Office Action Summary

09/427,260

KHOSRAVI ET AL.

DETAILED ACTION

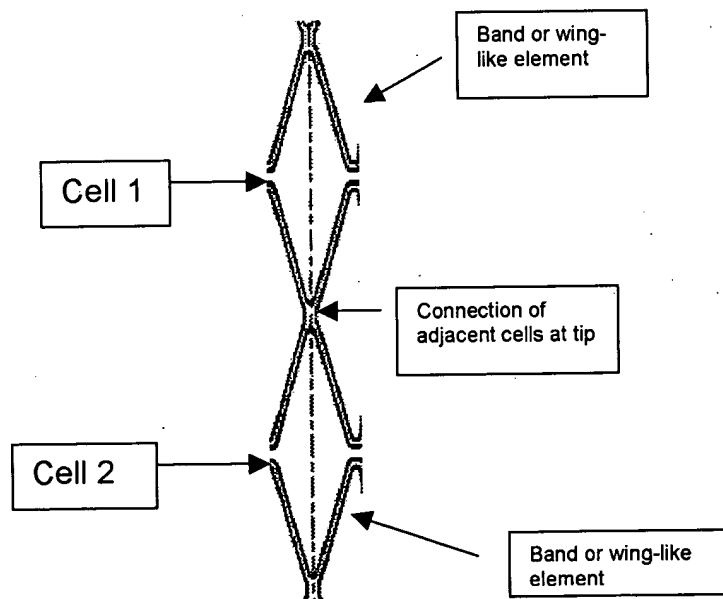
The drawing correction for Fig. 9 was received on 11/20/03. This drawing is not acceptable because it is not clear how the locking elements would work with the wing-like elements since the wing-like elements permit flexibility. Additionally, there is no description of an embodiment of this combination of features.

Applicant's arguments filed 11/20/03 have been fully considered but they are not persuasive. As mentioned above, it is the Examiner's position that the specification does not disclose the combined teaching of wing-like elements with locking elements and the amended Fig. 9 is new matter. After further review also, Fogarty can be interpreted in its broadest reasonable sense to anticipate the claims, since the limitation "wing-like" is broad. In response to applicant's argument that there is no suggestion to combine the references, the examiner recognizes that obviousness can only be established by combining or modifying the teachings of the prior art to produce the claimed invention where there is some teaching, suggestion, or motivation to do so found either in the references themselves or in the knowledge generally available to one of ordinary skill in the art. See *In re Fine*, 837 F.2d 1071, 5 USPQ2d 1596 (Fed. Cir. 1988) and *In re Jones*, 958 F.2d 347, 21 USPQ2d 1941 (Fed. Cir. 1992). In this case, the features of either Gray or Khosravi can be said to improve the stent of Fogarty.
